TECHNICAL BULLETIN

File No.:	TB-9607	Date:	March 21, 1996
Model:	FT-1000MP	Serial No. Range:	Complaint Unit

Problem:	Critical power adjustment with processor switch turned on.
----------	--

AF UNIT

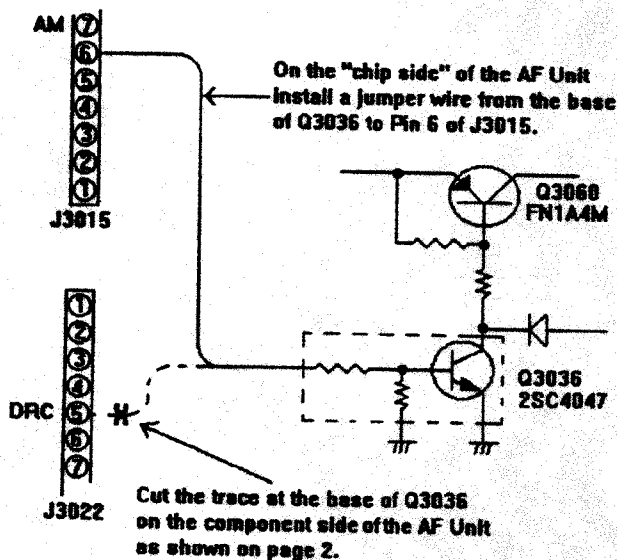
Expected Results of Modification:	Improve power control range.
-----------------------------------	------------------------------

CORRECT ADJUSTMENT OF PROCESSOR POT

1. Set the mode switch to CW and adjust the output power (i.e. 50 watts).
2. Set mode switch to SSB and processor off. Key transmitter and adjust microphone gain for proper ALC level on the ALC meter.
3. Press the processor switch to on. Set meter to COMP position and with transmitter keyed and modulated, adjust comp level on the meter for approximately 10 db.

NOTE: It is normal for the ALC reading to go above the top of the ALC zone intermittently.
